**DATE:** 02.27.2019  
**TO:** ProTrak  
**FROM:** Mitesh Baxi  
Traffic Engineering

■ **FLOW ACURA [TRC Plan Review]**

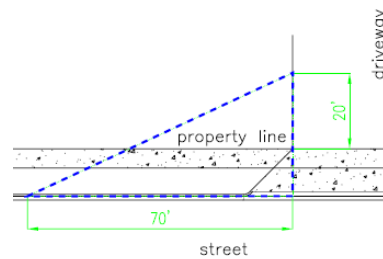
- Revise relevant sheets to accurately illustrate the existing conditions on and surrounding this parcel. Show all adjacent traffic signs, lane configurations, traffic control devices and pavement markings for the intersection of Bob King Dr and New Centre Dr on the site inventory plan. Please refer to the Technical Standards and Specifications Manual (link is below) Ch. VII C.1.a.2.for specific information and distance requirements. Contact Traffic Engineering at 341-7888 if you need assistance locating these elements.  
<https://www.wilmingtonnc.gov/home/showdocument?id=1910>
- If pavement markings on site have weathered to the point they are not in accordance with the MUTCD standard of maintenance, it is developer’s responsibility to maintain it in accordance.
